Franklin Township

Township Technical Review Committee (TRC)

MEMORANDUM

Re: Kingsley Sackey 1465 Easton Avenue (Block 466 Lot 9)

Figure 3: Building plans

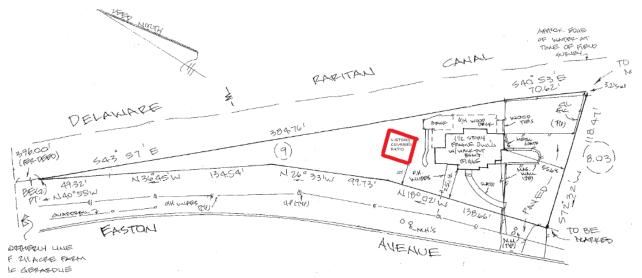
Applicant seeks to build a 20' x 20' covered pavilion in their side yard. The placement creates need for the following variances:

- Front Yard (accessory structure): 55¹ feet required 25 feet proposed
- Rear Yard (accessory structure): 25 feet required 10 feet proposed
